Subject: Front Steering Hoses Recall

Bulletin Type: Service Campaign Recall

Bulletin No:TS45-SR-1902

Vehicle Model: TS45

Figure-1

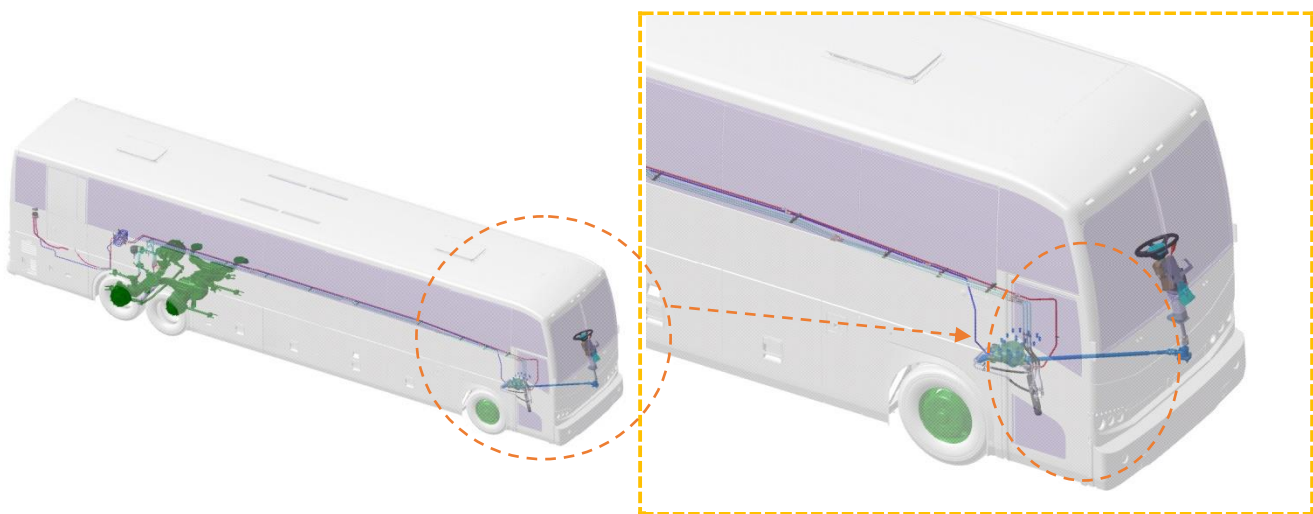
2. Application area; (See Figure-1 and Figure-2)

Figure-3

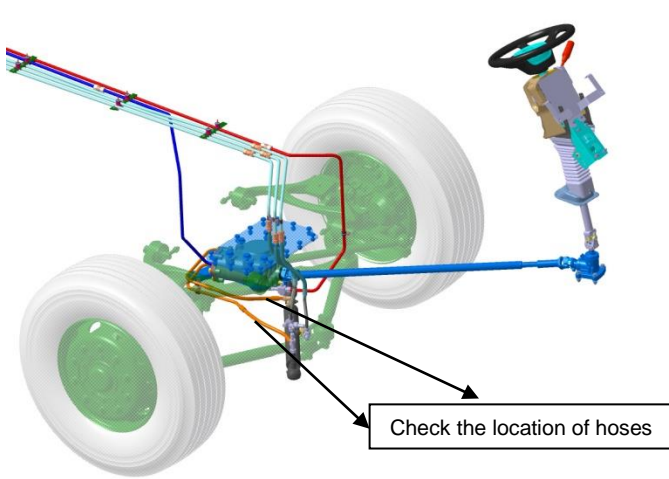
3. Check the steering hoses shown in the picture below (See Figure-3 and Figure-4)

Figure-6

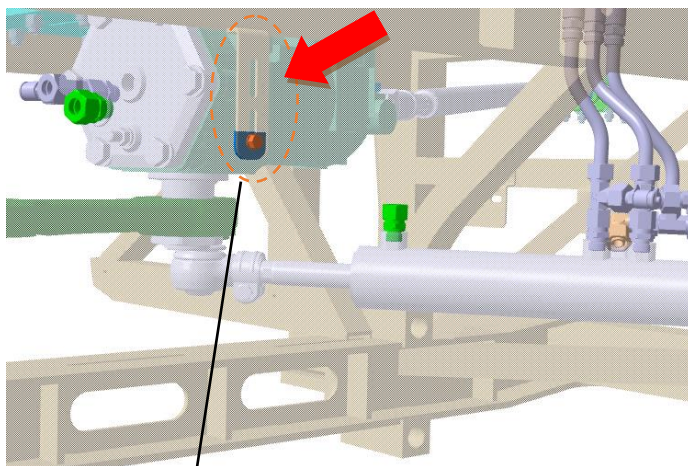
4. Dismount the clips which are assembled on the bracket (shown with red arrow) and mount the 9326-7238Y numbered bracket (shown with blue color in **Figure-7**) with using MF140005Y numbered bolt and MF434103Y numbered nut. (Tightening torque value is **3.69 ft-lb / 5Nm**). Then fix the 9326-7238Y by applying adhesive sealer. Bonding process must be done by applying adhesive sealer that the adherend part can not be detached.

Figure-8

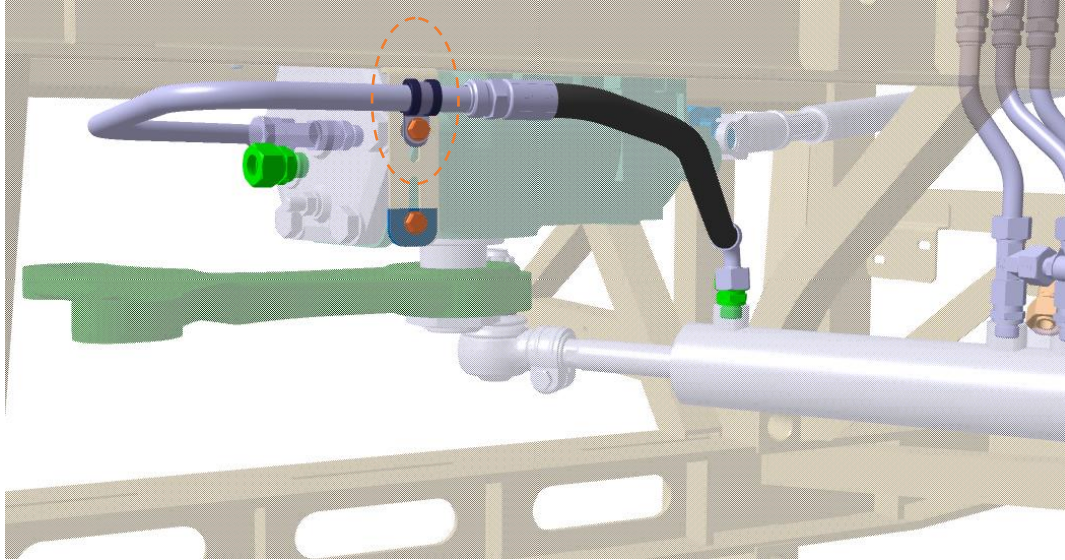
5. Fix the hose and pipe on the chassis with using MH020805Y numbered clip as shown in the picture below (Tightening torque value is **3.69 ft-lb / 5Nm**). (See **Figure-8**)

Figure-9

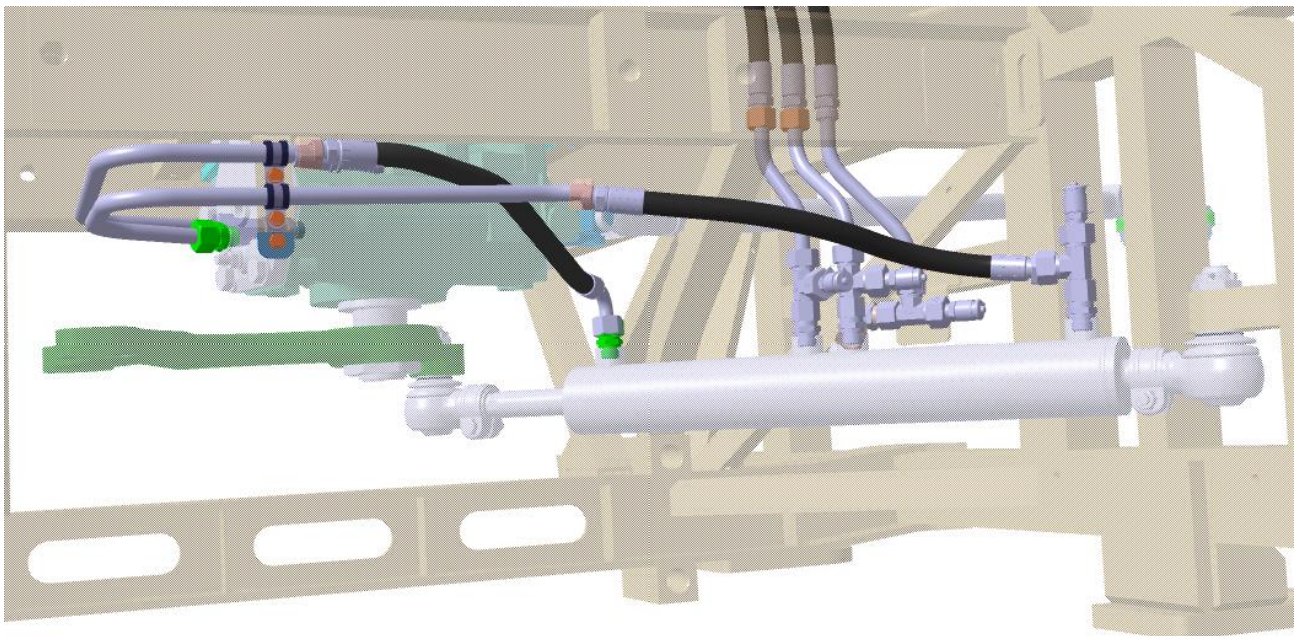
6. Fix the hose and pipe on the chassis with MH020805Y with using MH020805Y numbered clip as shown in the picture below (Tightening torque value is **3.69 ft-lb / 5Nm**). (See **Figure-9**)
